Subject: Military Cutoff Road (SR 1409) from just North of US 74
(Eastwood Road) to Market Street. State Project No.
8.2251001, Federal Project No. NHF-1409; TIP U-2734.

STORMWATER MANAGEMENT PERMIT APPLICATION FORM
NORTH CAROLINA DEPARTMENT OF TRANSPORTATION
LINEAR ROADWAY PROJECT

Subject: Minutes from Interagency Hydraulic Design Review Meeting on March 28, 2002 for U-2734 (Military Cutoff Road Widening), New Hanover County

Subject: Draft Minutes from Interagency Permit Review Meeting
on February 20, 2003 for U-2734 in New Hanover County

PROJECT REFERENCE NO.	SHEET NO.
	U-2734	14
	R/W SHEET NO.	14
	ROADWAY DESIGN ENGINEER	HYDRAULICS ENGINEER
PRELIMINARY PLANS <small>NO. 207 - USE FOR CONSTRUCTION</small>		
CONST. REV. _____ R/W REV. 07/16/03

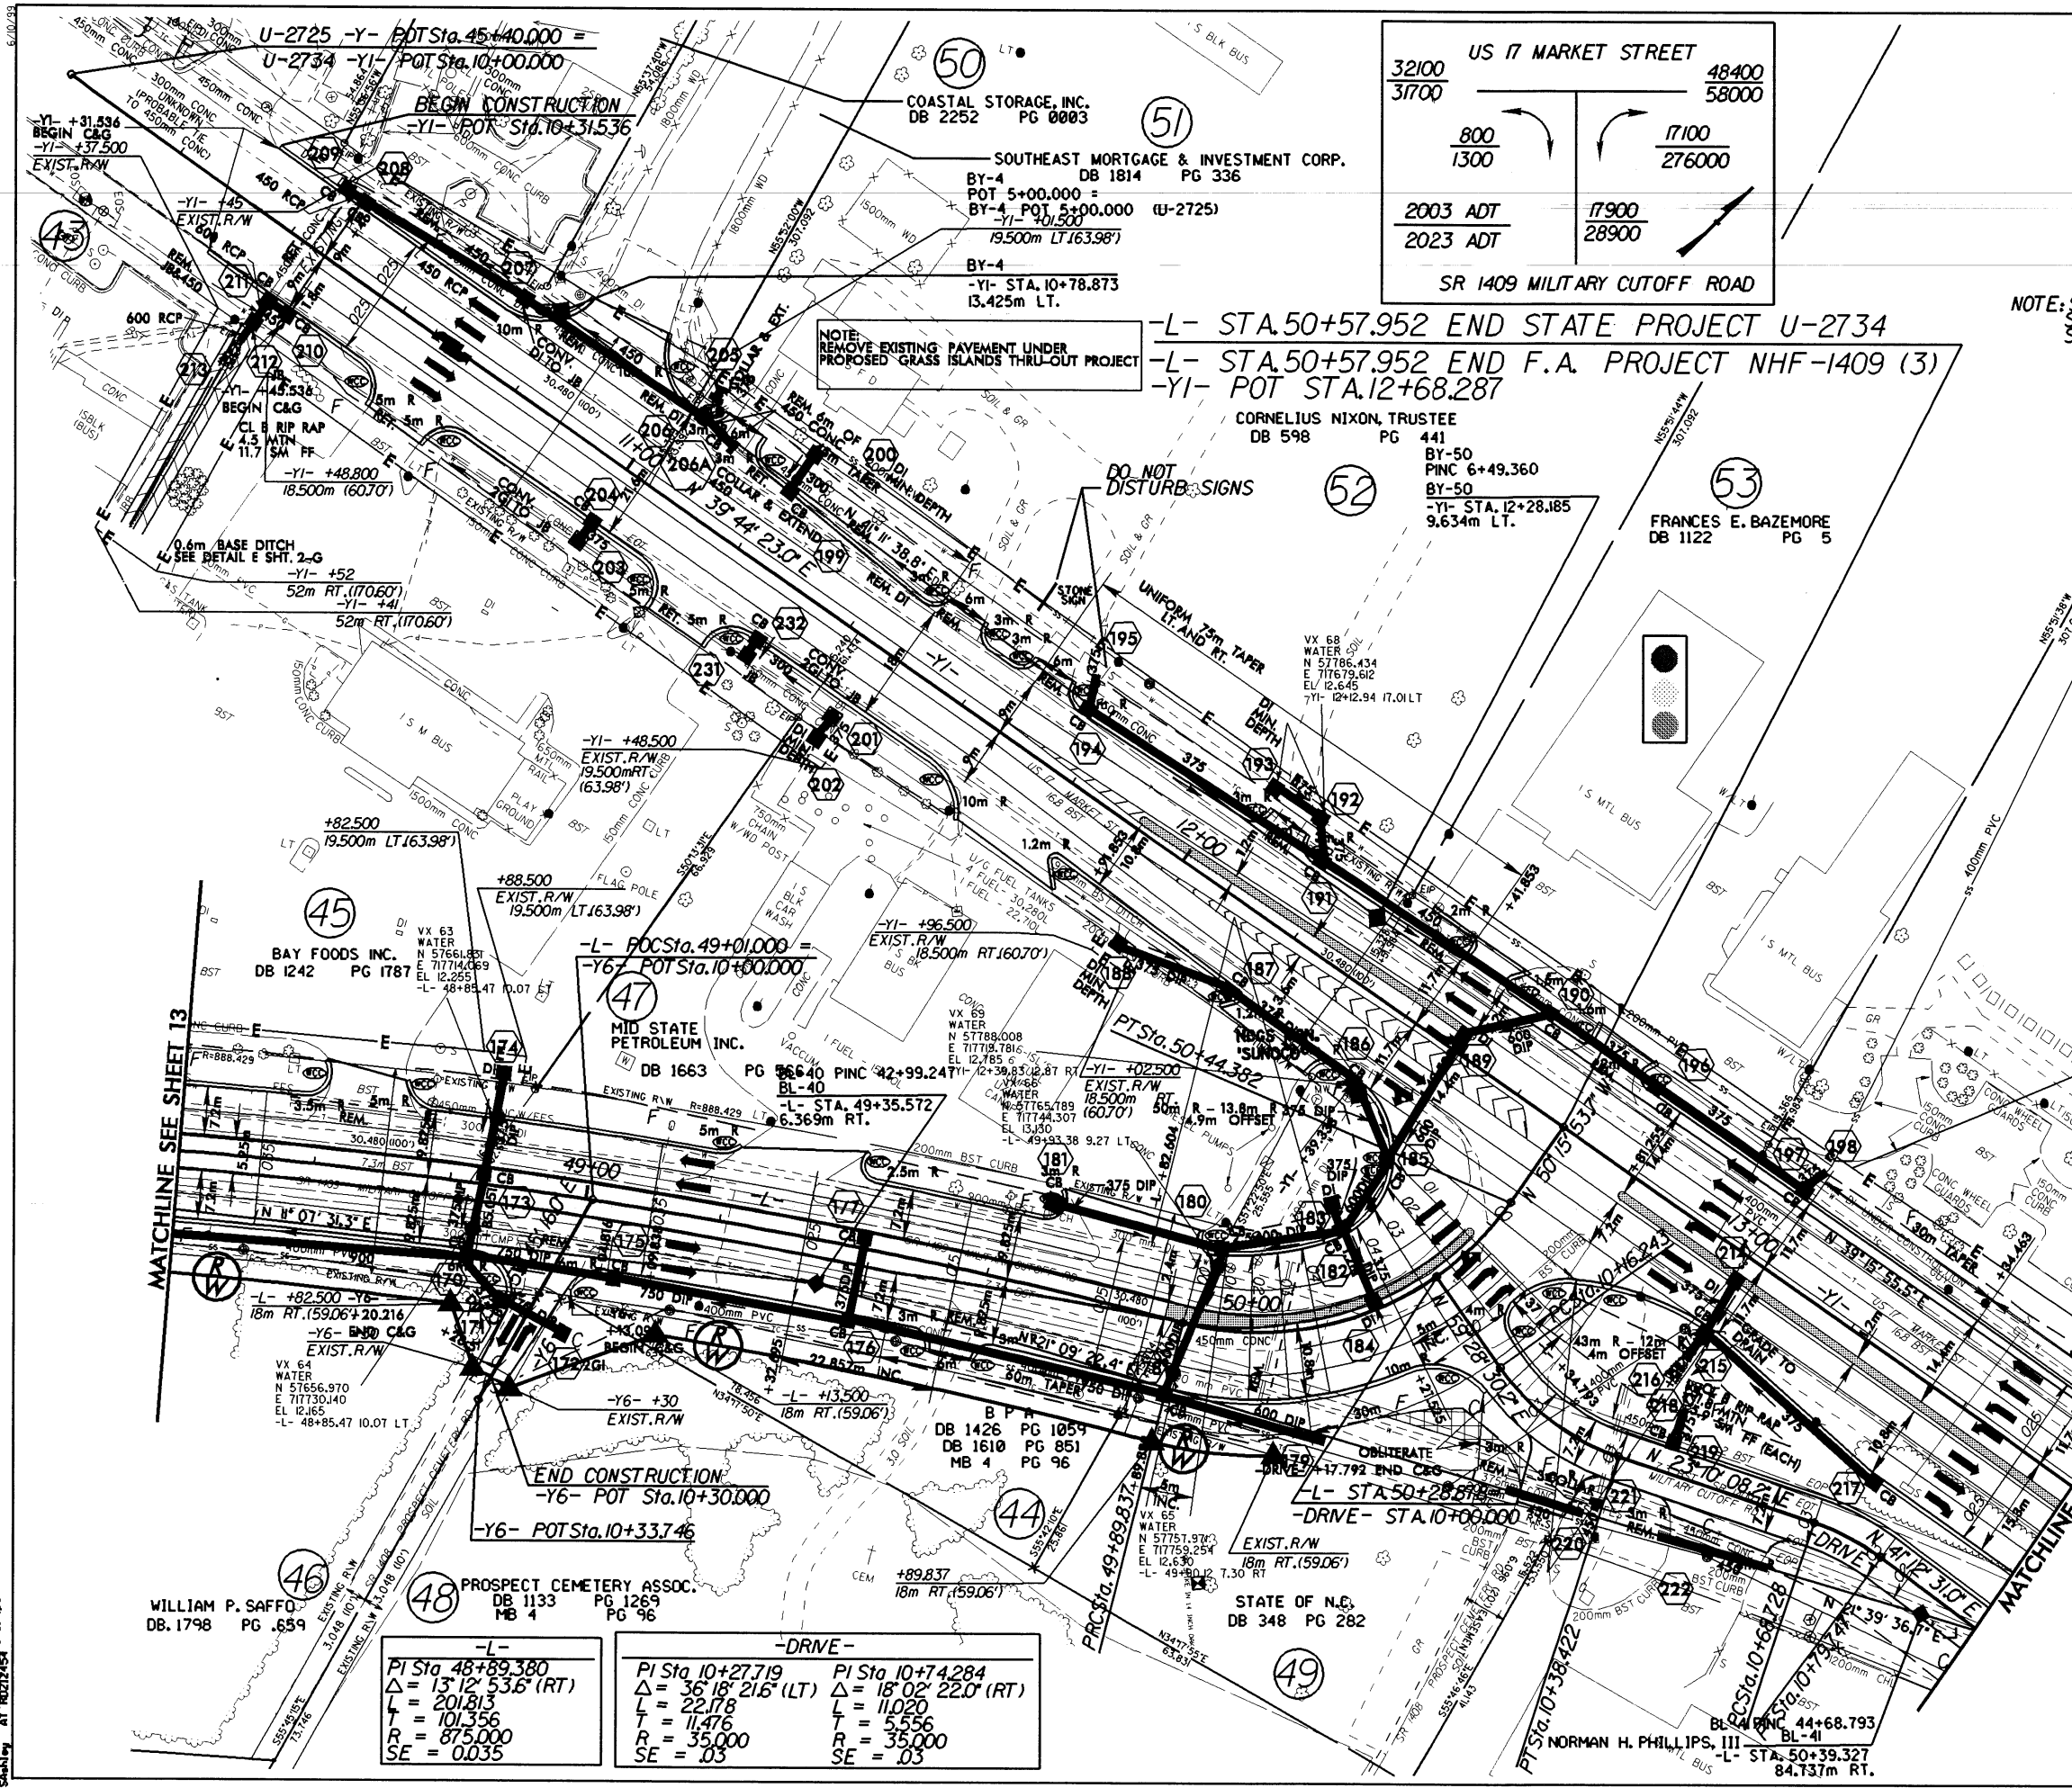
RIGHT OF WAY REVISIONS 07/16/03: REVISED DRAINAGE TO AVOID SIGN ON PARCEL 52
